RE: Mitigated Determination of Non-Significance (MDNS)
SEPA File No. CDR 20-001

I reviewed the Mitigated Determination of Non-Significance (MDNS) prepared by the City of Sequim for the Jamestown S'Klallam Tribe Outpatient Clinic Application (File No. CDR 20-001) **This document does not meet the Department of Ecology's requirements to fully and accurately assess the potential adverse and positive impacts of a proposed project.**

Comments to
Mitigated Determination of Non-Significance

Drawing to the right shows the street running east to west as the “PROPOSED 60’ WIDE RIGHT-OF-WAY” with “W. Hammond St” identified. (Drawing C1.0 from JTSK Architect Rice Ferus Miller-SEPA Attachment)

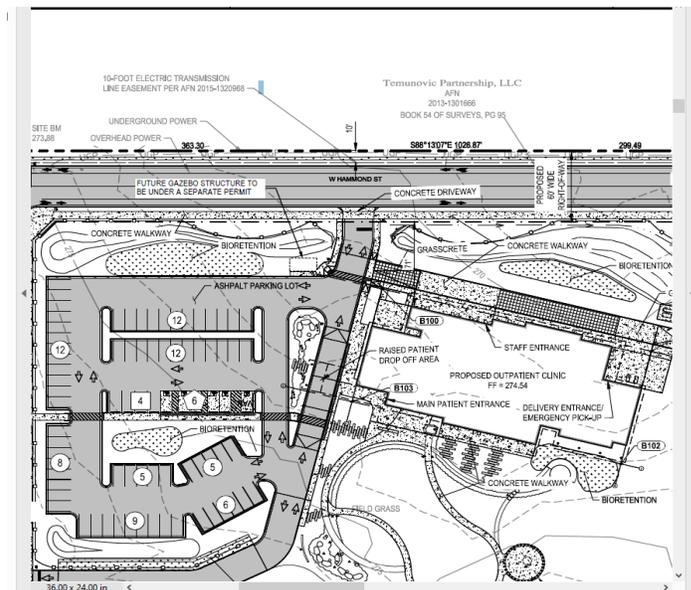
Comment to A.9:

The Hammond/Prairie Streets, Highway 101 bypass which, although not “pending” with the city, is included with this project being planned by the Applicant/Developer (see above): *“The project is planning to extend the existing 9th Ave right-of-way south to the project main entrance as shown in the preliminary site plan is provided in Figure 2. **The project will also construct a new road (West Hammond Street) along the north side of our property that will consist of two 11’ traffic lanes and a 6’ bike lane on each side.**”*

(emphasis mine) (Transportation Engineering Northwest-Traffic Impact Analysis, 1/10/2020). Who will pay for the construction? Who will own and maintain the streets constructed for the purpose of accessing the MAT clinic? There are unverified reports that a 9th Ave exit/entrance direct to Hwy 101 from the project property is the end goal. Who pays for that? None of the construction nor maintenance of future streets used for this project's purpose should be at taxpayer expense in building and maintenance nor, however, should the Applicant/Developer be able to pick and choose which streets are built to further their project.

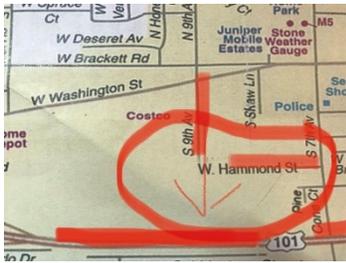
- The proposed use includes childcare, however, no mention of permit or licensing for childcare is included in the Application.
- The Applicant/Developer previously cites Phase 1 and Phase 2 plans, **"The Tribe also plans to build a 16-bed psychiatric treatment (E&T) hospital that will open in 2022..."** (emphasis theirs). The Applicant/Developer has since denied that Phase 2 is part of this application. The \$7.2 million grant includes infrastructure for phase 2. The map below (Krazan & Associates Geotechnical Engineering Investigation, October 24, 2019, Figure 2) clearly shows the 16-bed Psychiatric (E&T) unit as part and parcel to Phase 2. Also included with these plans in this document, but not addressed in this application: housing. Shown as "FUTURE HOUSING" (Figure 2, below).

- PHASE 1
- PHASE 2
- 16 BED BEHAVIORAL HEALTH (psych)
- Housing
